UNITED STATES PATENT AND TRADEMARK OFFICE

APPLICATION NO.	FILING DATE	FIRST NAMED INVENTOR	ATTORNEY DOCKET NO.	CONFIRMATION NO.
09/687,020	10/13/2000	Eric C. Coad	55202USA1A.002	9163

Office Action Summary	Application No.	Applicant(s)
	09/687,020	COAD ET AL.
	Examiner Hadi Shakeri	Art Unit 3723

DETAILED ACTION

Fig.7

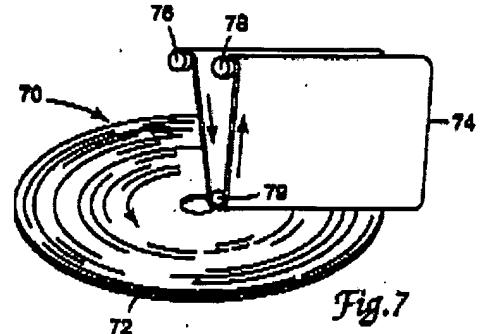
10. Claims 1-32 are rejected under 35 U.S.C. 103(a) as being unpatentable over Martin et al. in view of Ohishi, Patent No. 5,733,178.

Ohishi discloses all the limitations of claims 1 and 20, except for disclosing the diamond-like carbon coating. Martin et al. teaches an abrasive article having a diamond like coating layer. It would have been obvious to one of ordinary skill in the art, at the time the invention was made, to modify the article of Ohishi with diamond-like coating as taught by Martin et al. to improve cutting performance. Regarding claims 2-19 and 21-32, prior art meets the limitations.
